Crystal River Nuclear Plant  
Docket No. 50-302  
Operating License No. DPR-72

February 26, 2009  
3F0209-02

Subject: Crystal River Unit 3 – Response to “Crystal River Nuclear Plant, Unit 3 - Request for Additional Information, Regarding Response to Generic Letter 2004-02 (TAC NO. MC4678)”

**RESPONSE TO REQUEST FOR ADDITIONAL INFORMATION  
REGARDING RESPONSE TO GENERIC LETTER 2004-02**

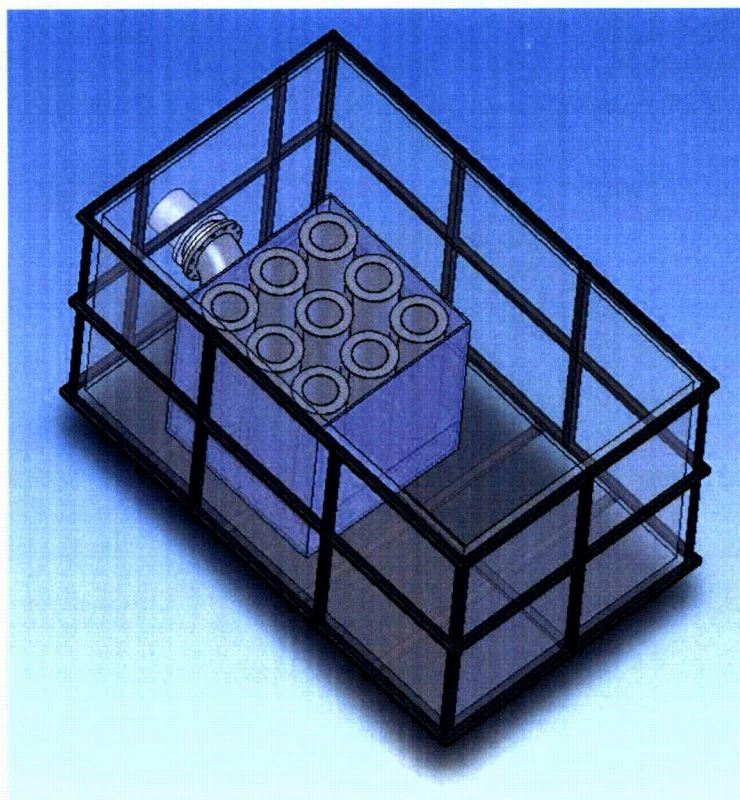
**RAI #4      Please verify that the stirring used to prevent debris settlement did not non-prototypically affect bed formation.**

**FPC Response to RAI #4**

Chemical Effects Testing for the CR-3 strainers was performed at the Alion test facility in Warrenville, IL, and monitored by Progress Energy personnel. The test utilized an approximately 6 feet tall by 6 feet wide by 10 foot long tank with a prototypical "top hat" strainer array. The strainer assembly was surrounded on all sides by panels designed to simulate sump pit walls (similar to the sump pit in the CR-3 reactor building). Pump suction was from the base of the sump, and the water was returned to the tank through a sparger located at the bottom of the tank along the back wall.

The sparger served to maintain the debris in suspension so that it could be transported to the sump pit and strainers. In addition, stirring was manually accomplished by slowly skimming the broad end of an oar across the bottom of the tank to lift any debris that may have settled, allowing it to be entrained in the current and transported to the sump pit.

The walls of the sump pit provided a physical boundary between the strainer array and the turbulence caused by the sparger and the oar. Therefore, the stirring did not non-prototypically affect the debris bed formation.

A model of the test assembly for Test #1, showing the 3 x 3 strainer array surrounded by walls on all four sides, is shown below. Test #2 used a similar arrangement, but with a 3 x 2 top hat strainer array.
